PREVOST

WARRANTY BULLETIN

WB24-41

DATE :	December 2024	SECTION :	06 ELECTRICAL
EXPIRATION:	December 2026		
SUBJECT :	CB9 WIRE CRIMP INSPECTION

9. Inspect the wire crimp on the ring terminal:

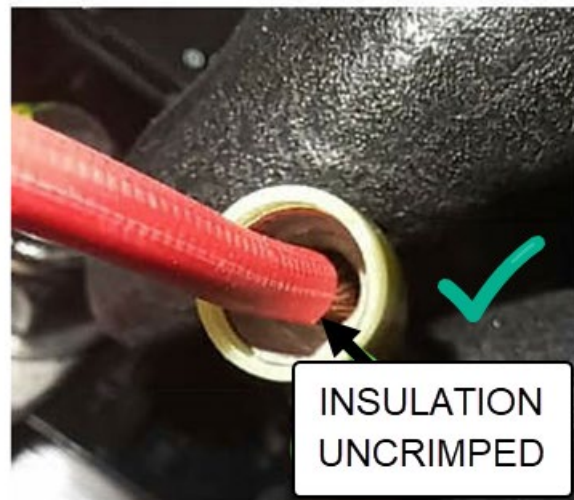
- If the wire insulation is crimped within the terminal barrel, the crimp is non-compliant. Proceed to the **Repair section**.
- If the stripped portion of the wire is securely crimped within the terminal barrel and the insulation remains uncrimped, the crimp is compliant. Go to **Reinstallation section**.

REPAIR (IF NEEDED)

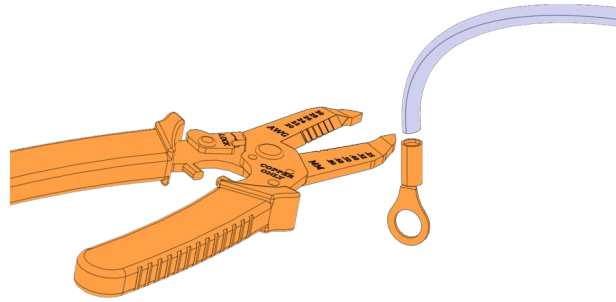
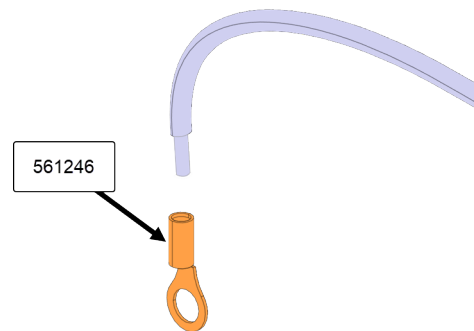
1. Cut off the incorrectly crimped ring terminal from the wire and discard it.
2. Strip the end of the wire.

3. Insert the striped portion of the wire into the barrel of new ring terminal 561246.
4. Crimp the ring terminal. The crimp should be tight and uniform, and the insulation should not be crimped.
